**Independent Market Operator**

**Rule Change Notice**

**Title: Removal of DDAP Uplift  
when less than facility  
min gen**

**Ref: RC\_2010\_08**

Figure 2.

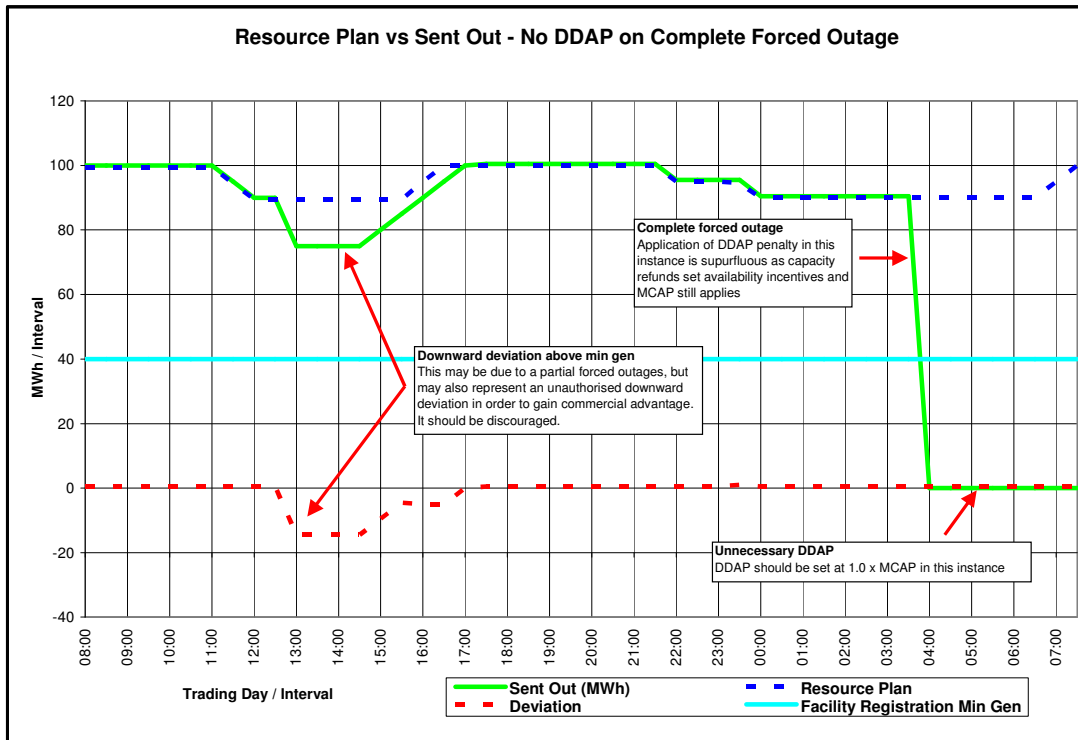
experienced a complete forced outage imposes an additional cost on the scheduled generator above the MCAP price as well as the cost of capacity refunds – which act as the specific market incentive to maintain available capacity. In other words, the DDAP penalty in this instance is superfluous.

The ramp-up profile in Figure 1 provides an example of how this rule would be applied during a downward deviation during ramp up and ramp down. Figure 2 provides an example of how it would be applied to forced outages:
